CHARTER TOWNSHIP OF GARFIELD PLANNING COMMISSION MEETING

Charter Township of Garfield Planning Department Report No. 2022-104			
Prepared:	November 2, 2022	Pages:	5
Meeting:	November 9, 2022 Planning Commission	Attachments:	<input checked="" type="checkbox"/>
Subject:	SPR 2022-16 Birmley Hills Site Condominium – Public Hearing		
File No.	SPR 2022-16	Parcel No.	05-026-020-30
Owner:	T&R Investments, Steve Zakrajsek		
Agent:	Boyne Engineering and Design

November 1, 2022

ORIGINAL ISSUE DATE: 09/21/2022
SCALE: 1"=50'
BED JOB NO. 22016
DRAWING NUMBER **C4.0**

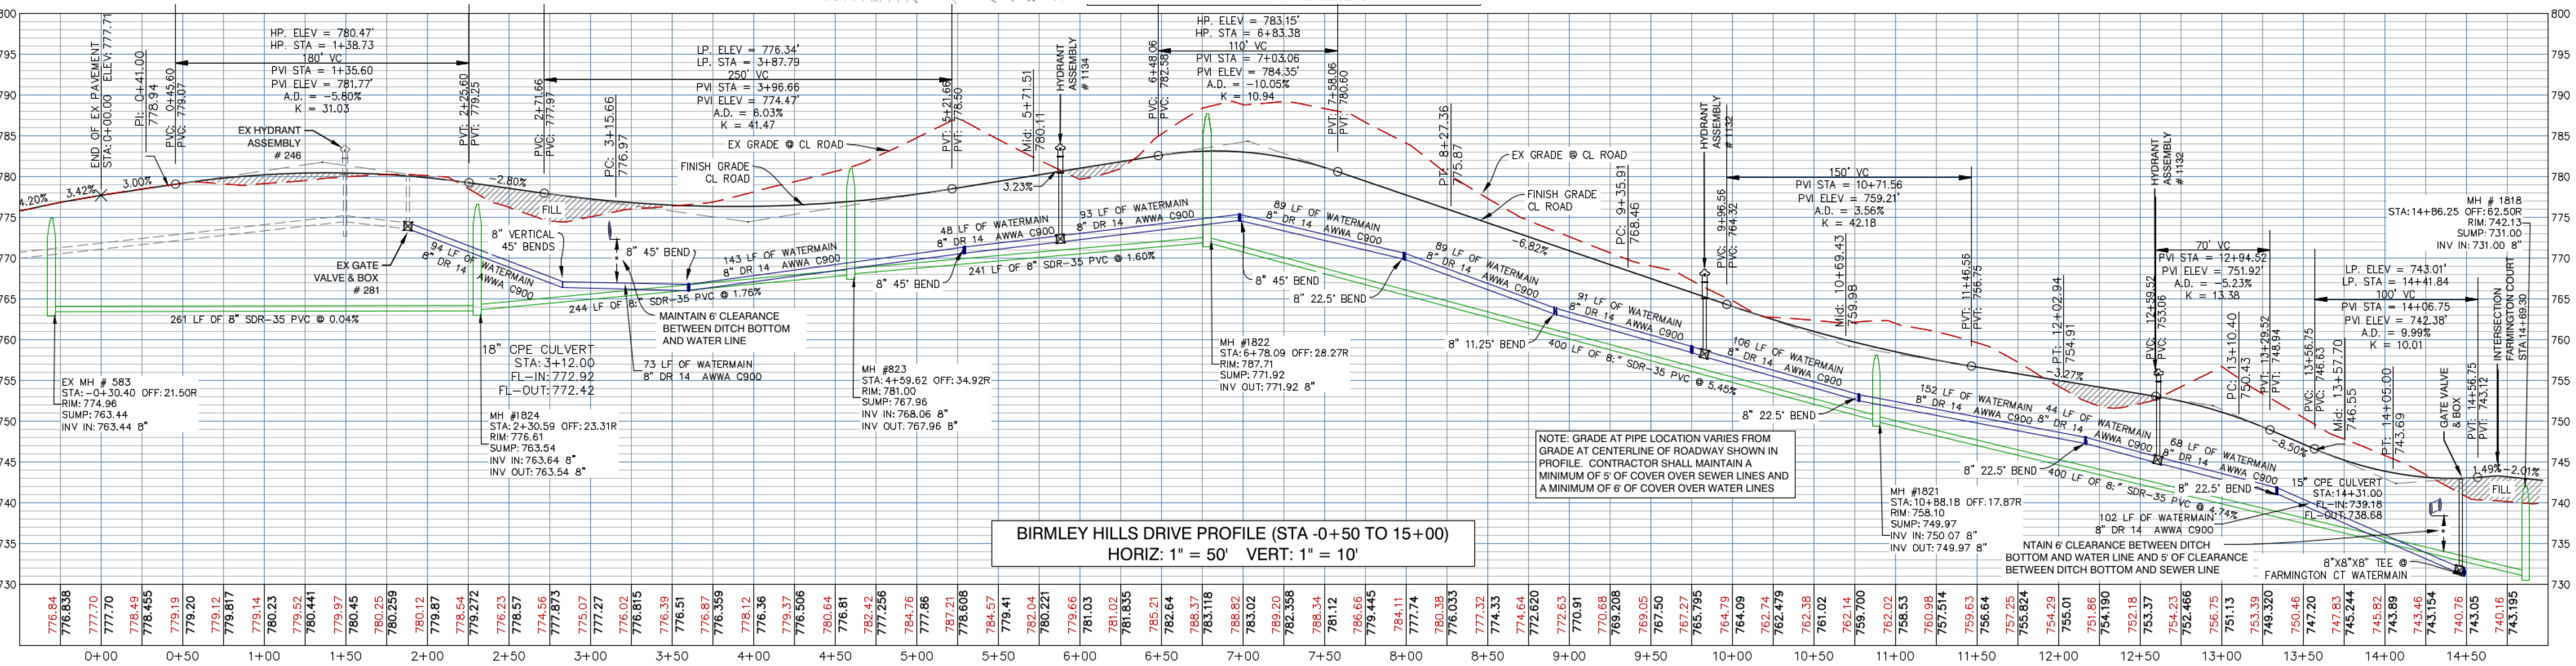
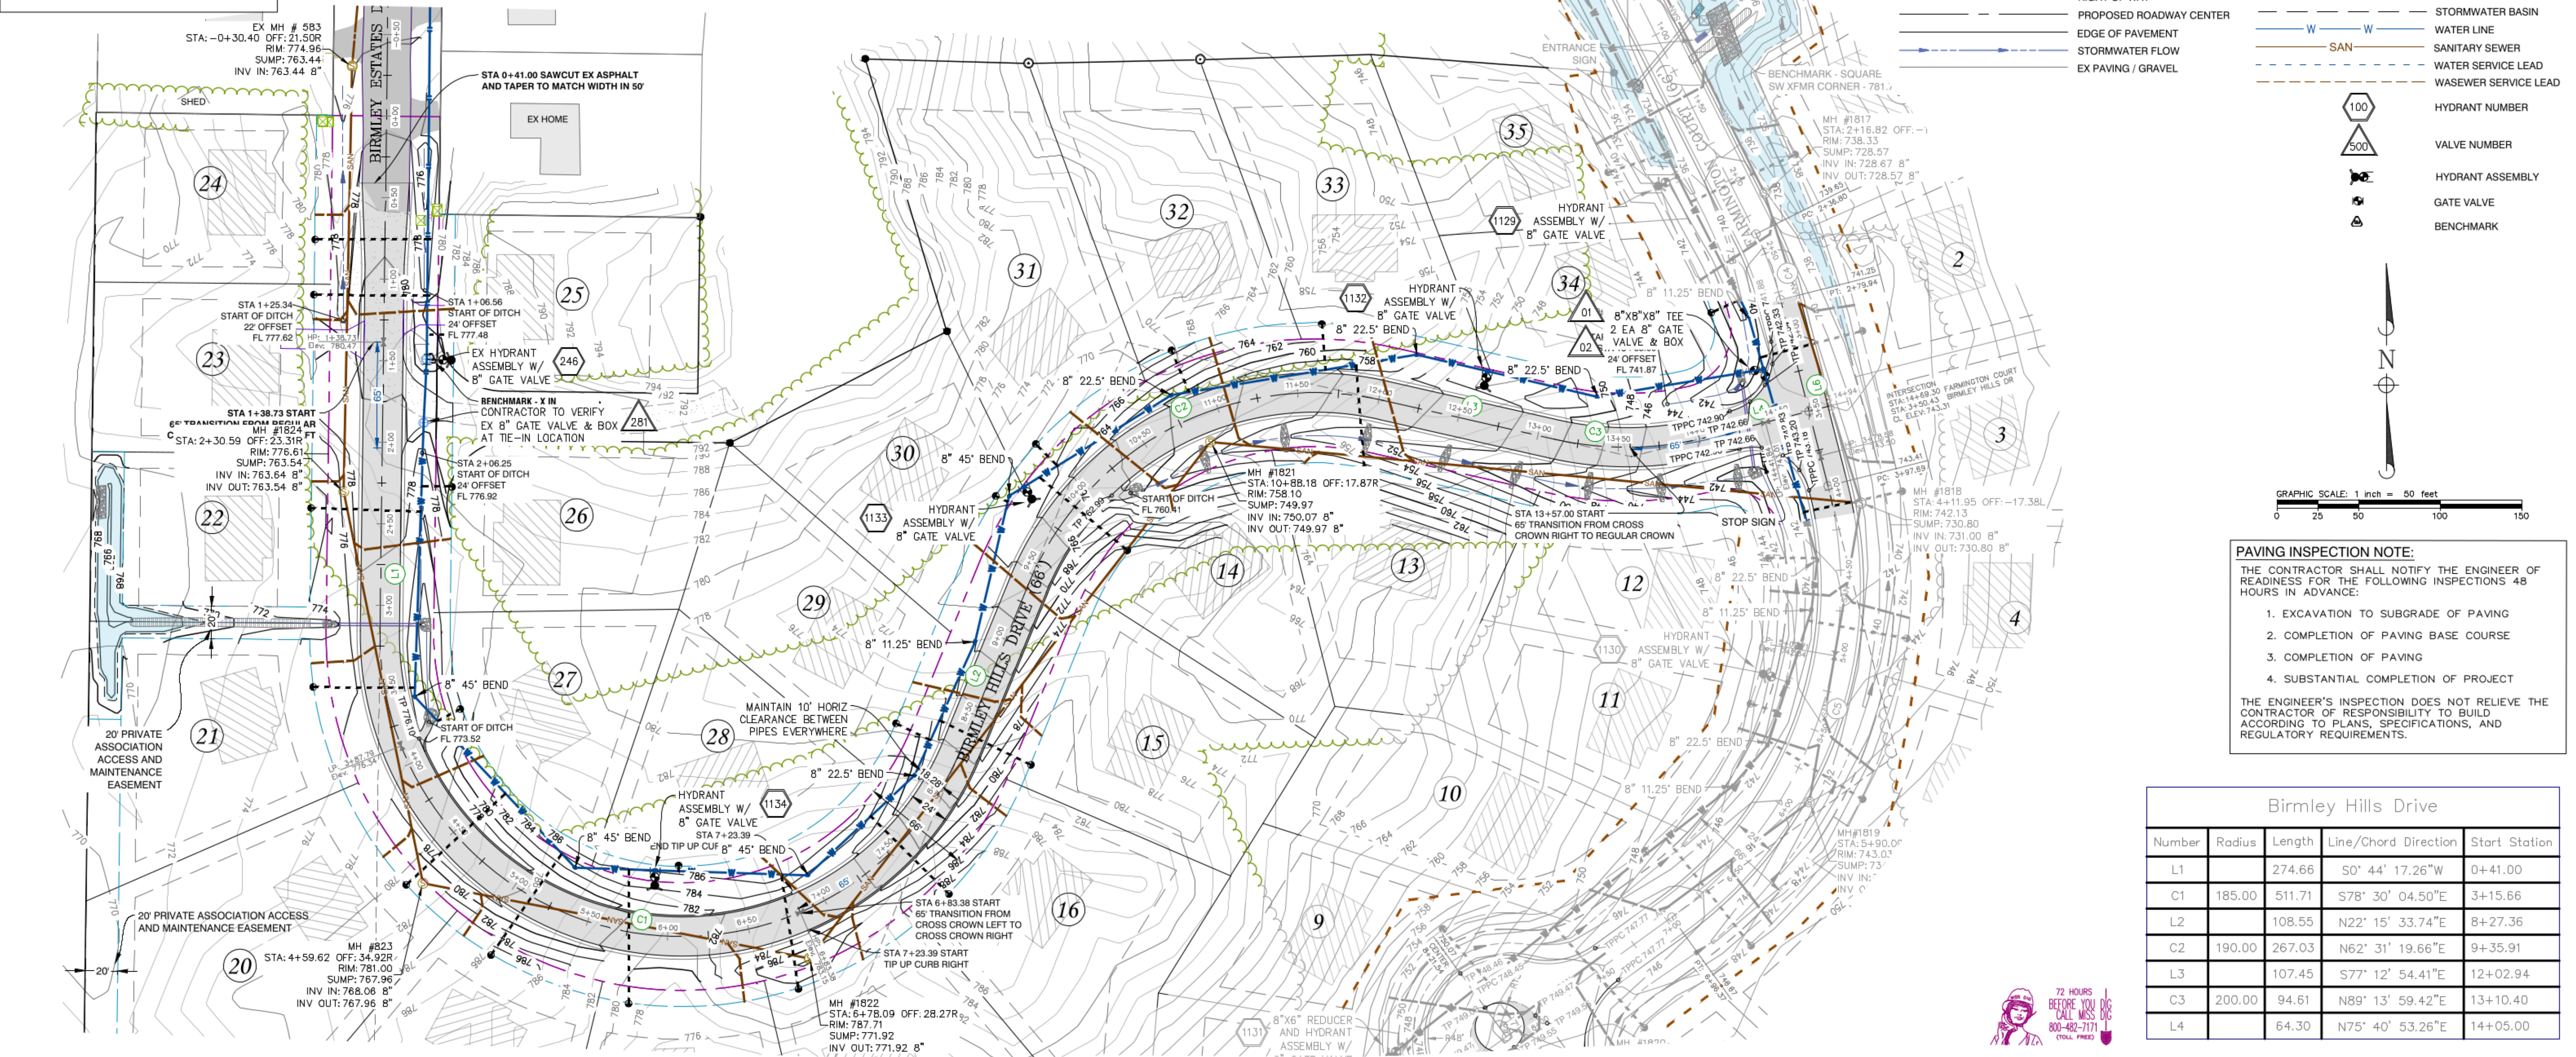
5. Water main stub shall be provided to the abutting western parcel to accommodate a future access.
6. A main line valves shall be installed on Sheet C4.0. Valves are to be installed every 1,000 feet to accommodate isolation.

**FARMINGTON COURT
 PLAN & PROFILE**

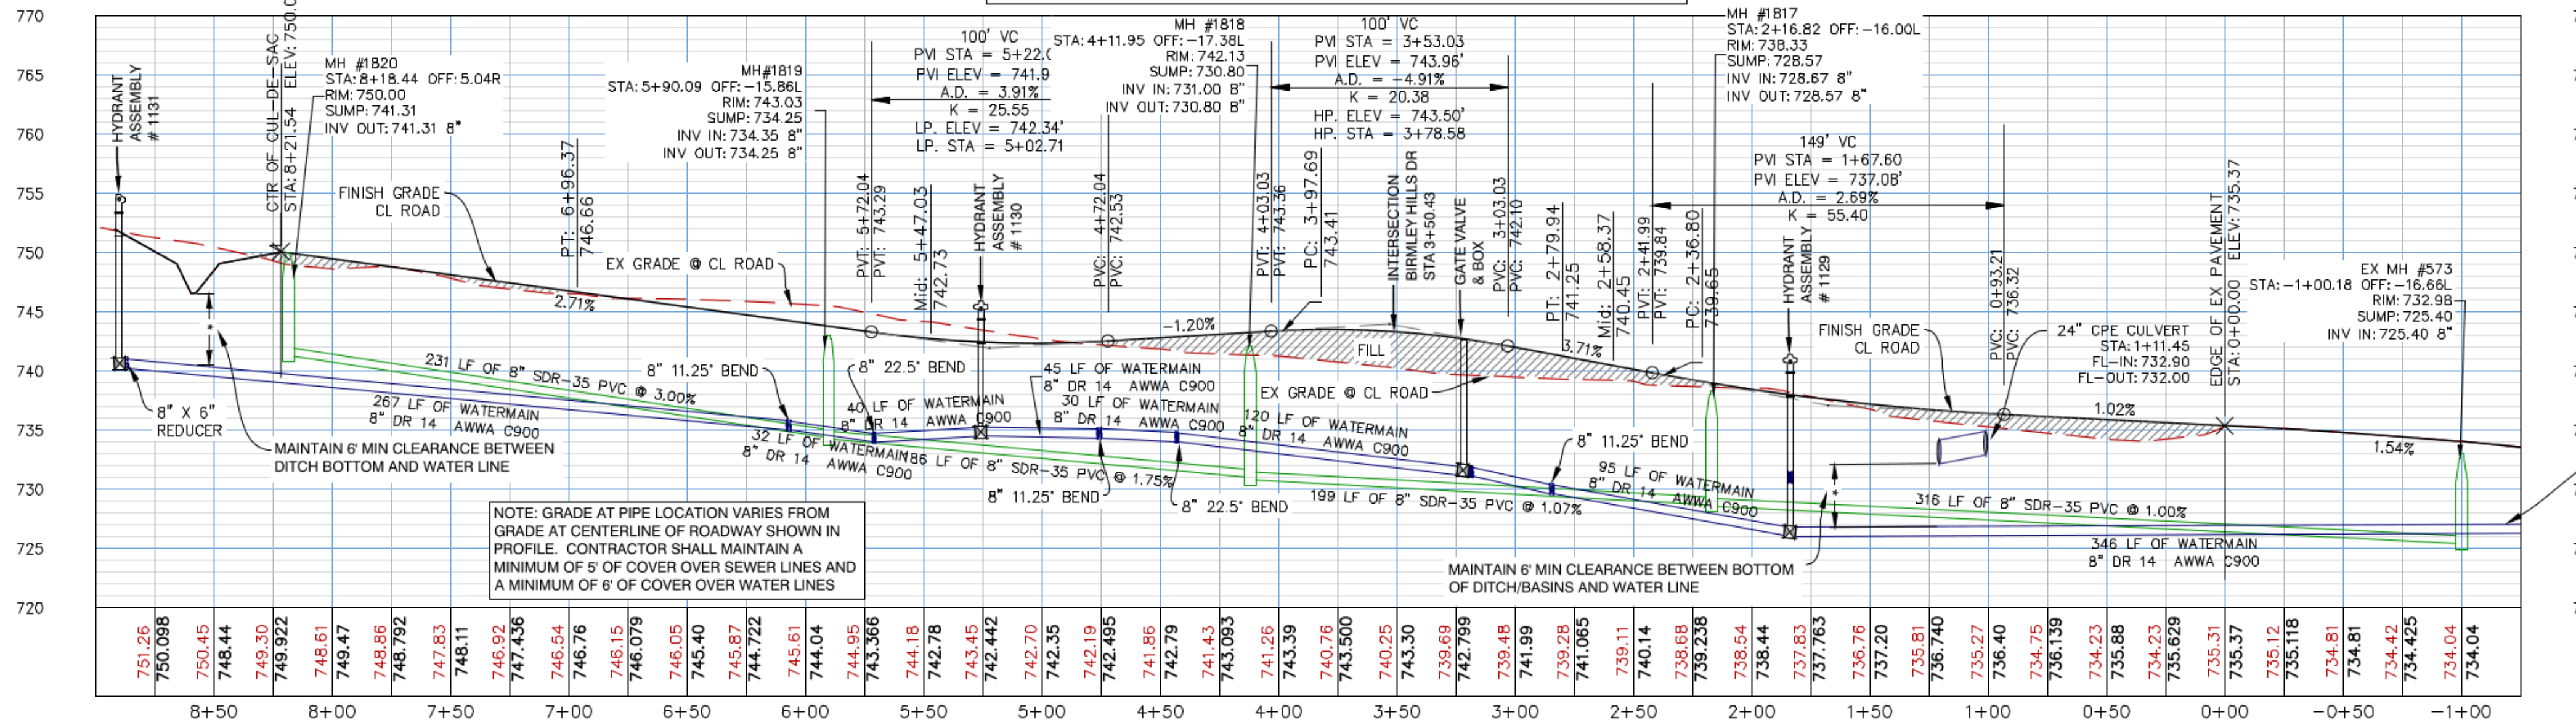
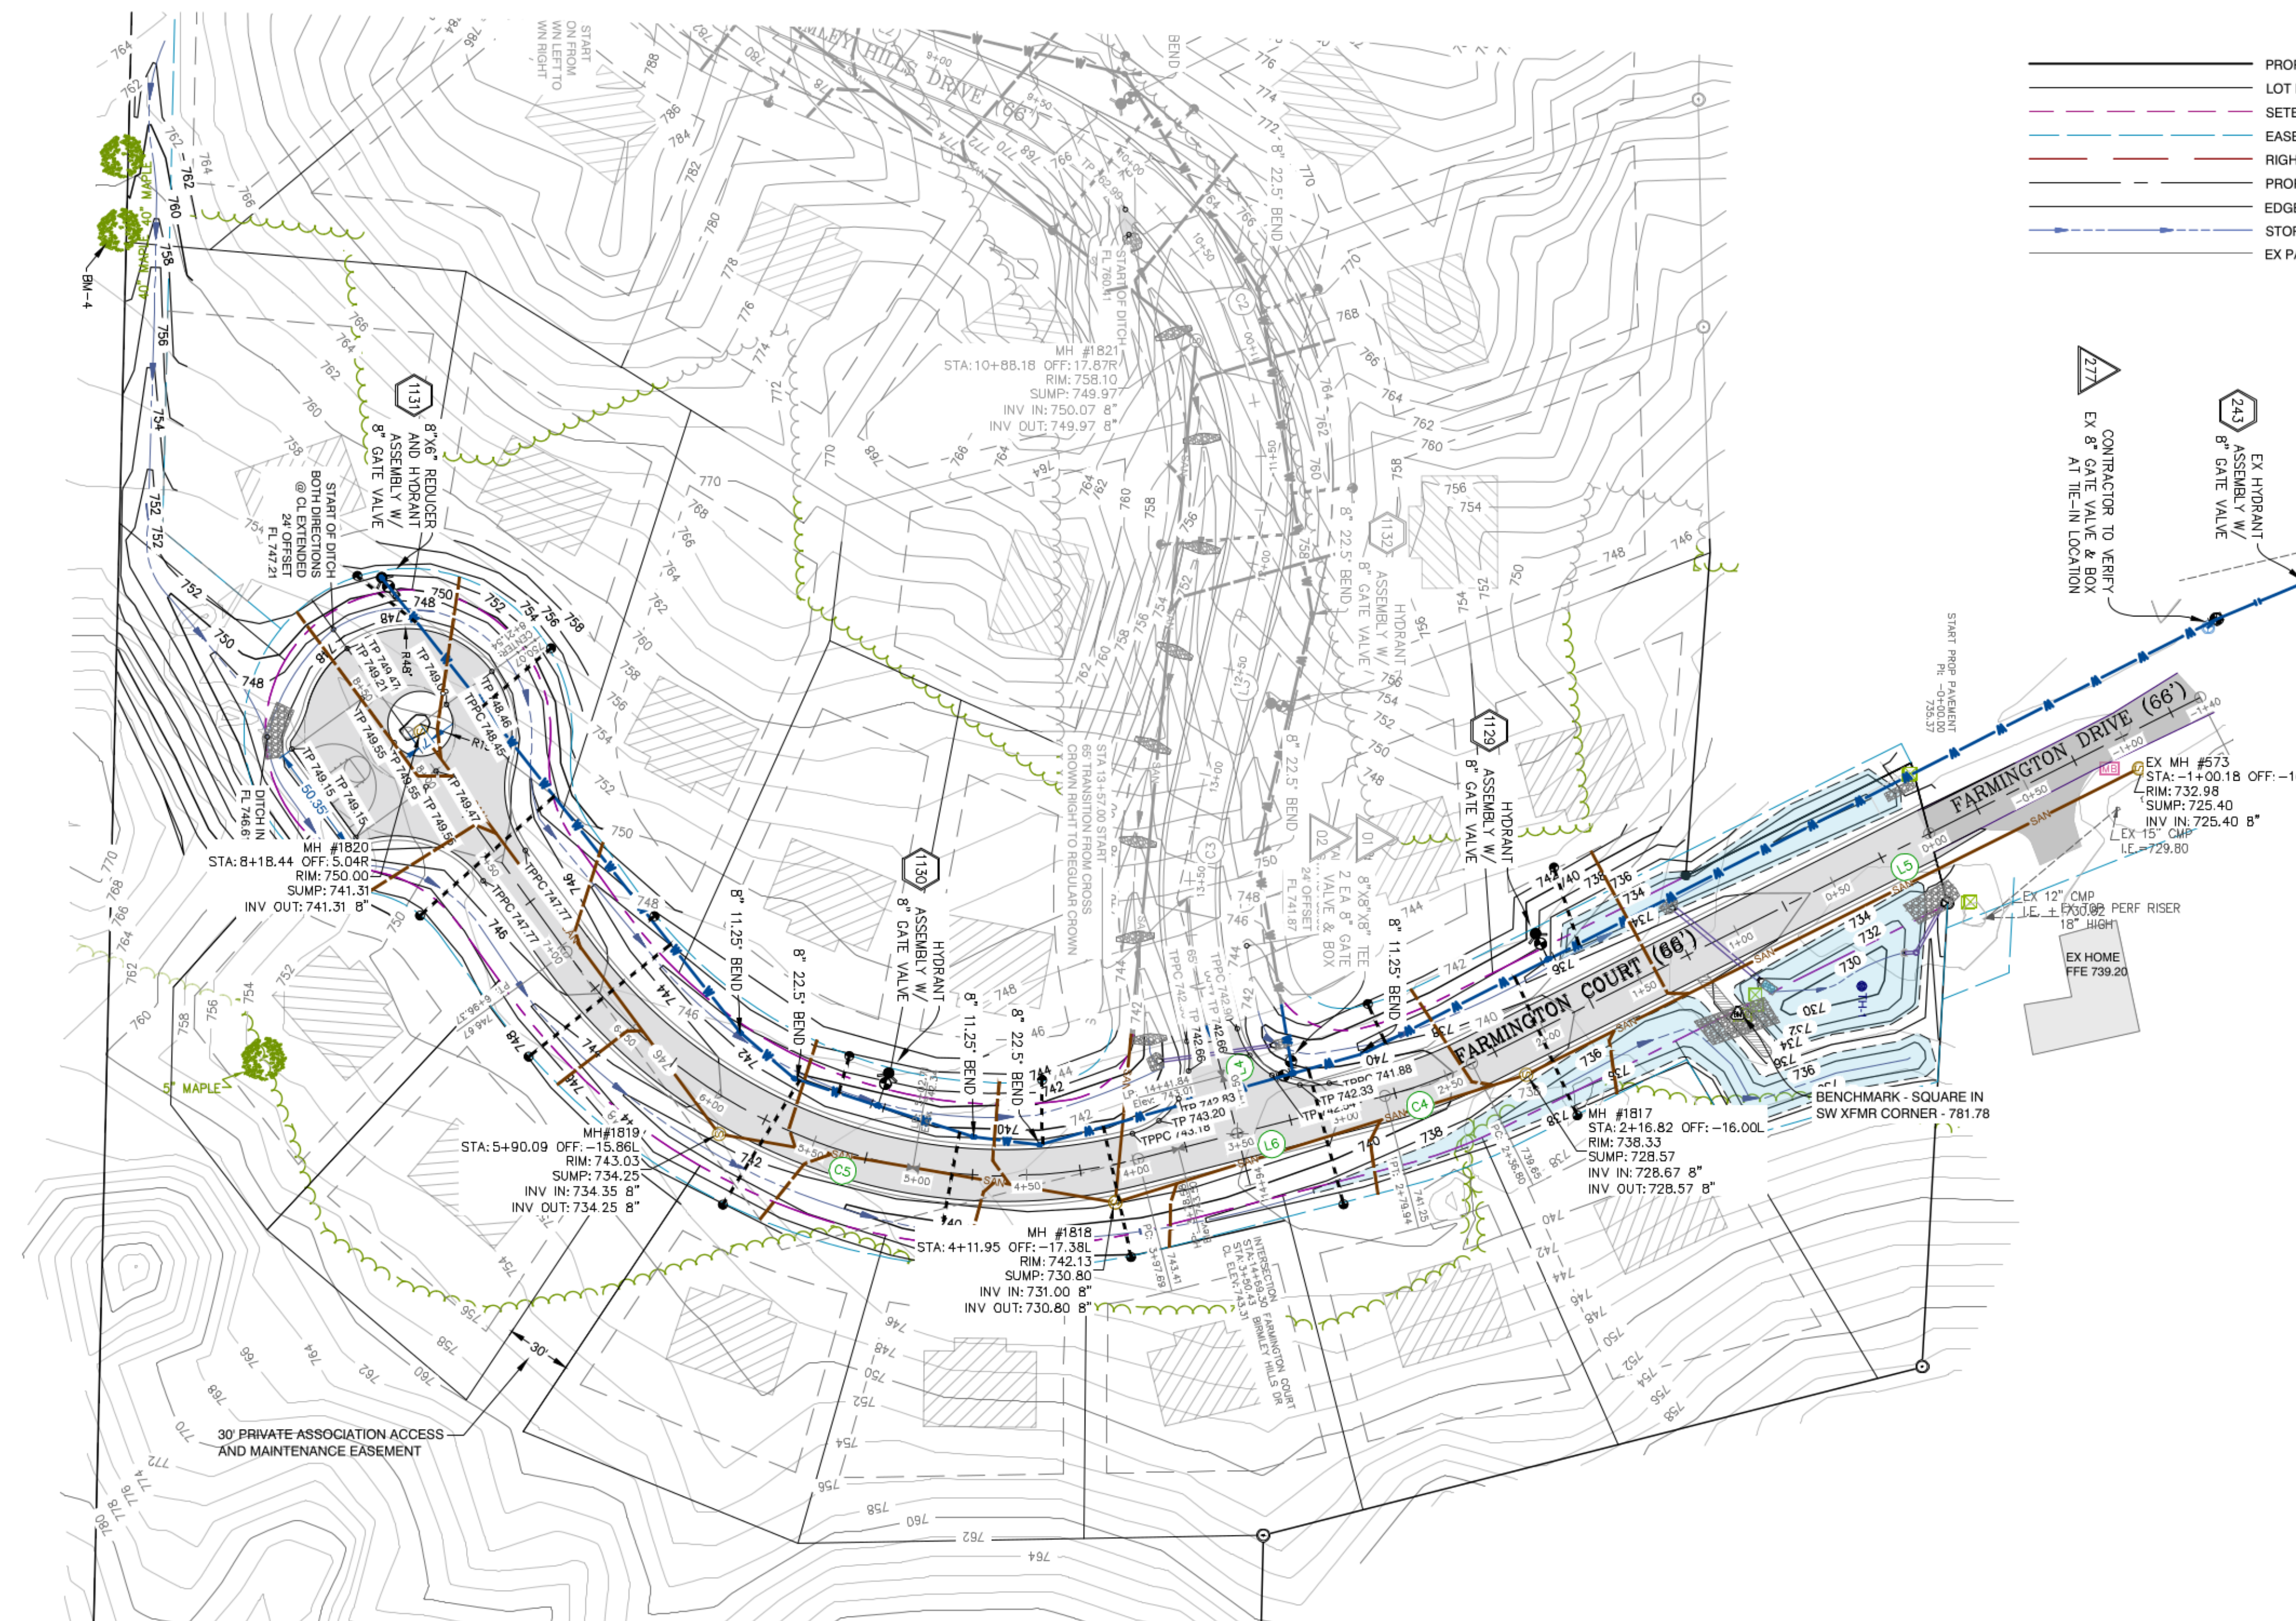
3. Please note that C900 DR 18 is a minimum requirement and DR 14 is proposed.
4. Sheet C4.1 profile sta. 3+25 to 2+75 water main length not called out.
